Addendum #1 – June 1, 2023

Livingston County Highway Department

Section 21-00230-00-BR

Summary of Changes: Remove Fabric Reinforced Elastomeric Mat from bid shown in CORNER DETAIL, Sheet 6 of the PLANS.

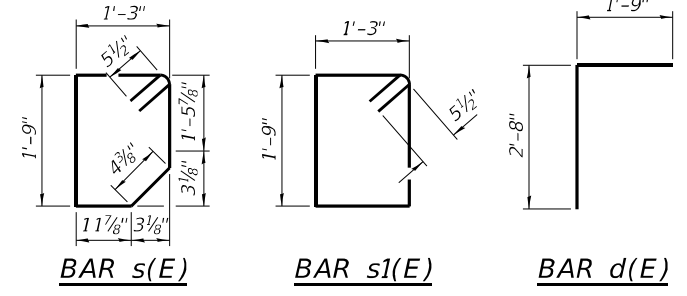
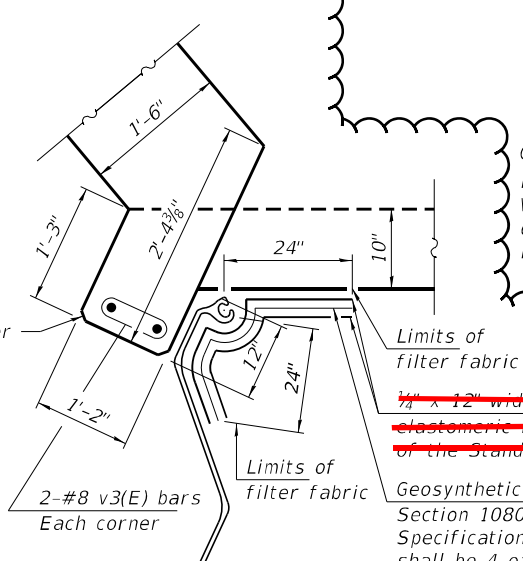
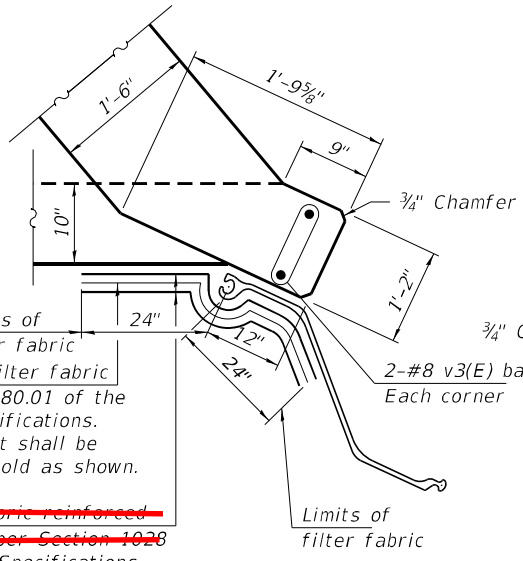
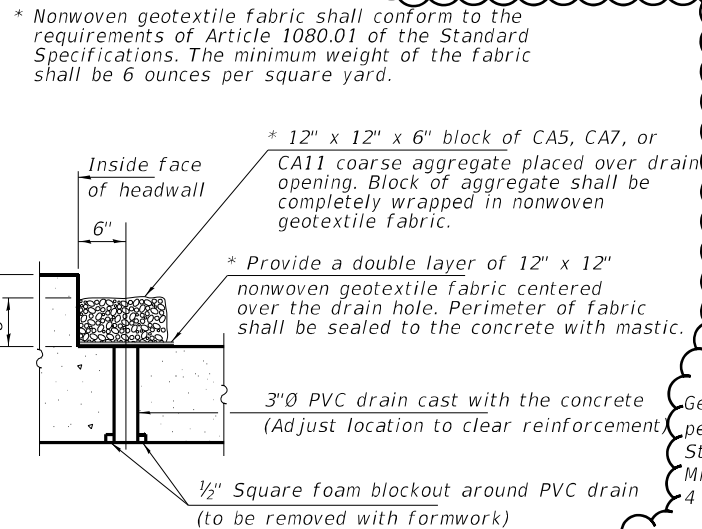
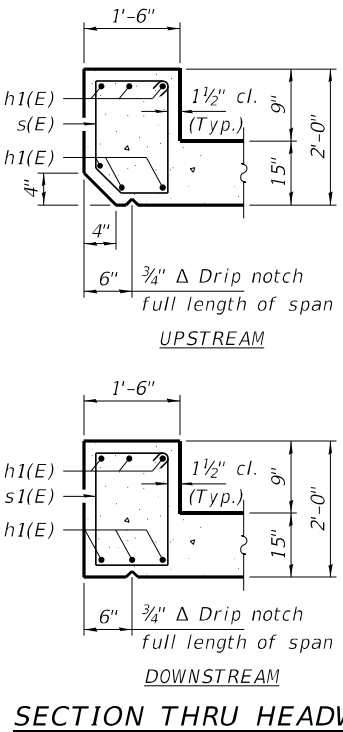
Addendum 1 05/31/2023
 The fabric reinforced elastomeric mat is deleted from the contract bid. The Geosynthetic filter fabric shall be included.

Notes:
 At the Contractor's option, a longer v1(E) bar may be ordered to replace the v(E) bar. No reduction in quantities shall be made for this substitution. The minimum effective section modulus of the permanent steel sheet pile wall shall be 26.2 in.³/ft and as shown on sheet 3 of 6. Sheet piling shall not be driven until the concrete strength has attained a minimum flexural strength of 650 psi or a minimum compressive strength of 3500 psi. The cost of furnishing and installing the bent sheet pile cap, filter fabric and ~~fabric reinforced elastomeric mat~~ shall be included in the cost of Permanent Sheet Piling.

Geosynthetic filter fabric per Section 1080.01 of the Standard Specifications. Minimum weight shall be 4 oz./sq. yd. Fold as shown.
~~1/4" x 12" wide fabric reinforced elastomeric mat per Section 1026 of the Standard Specifications.~~

Limits of filter fabric
~~1/4" x 12" wide fabric reinforced elastomeric mat per Section 1026 of the Standard Specifications.~~
 Geosynthetic filter fabric per Section 1080.01 of the Standard Specifications. Minimum weight shall be 4 oz./sq. yd. Fold as shown.
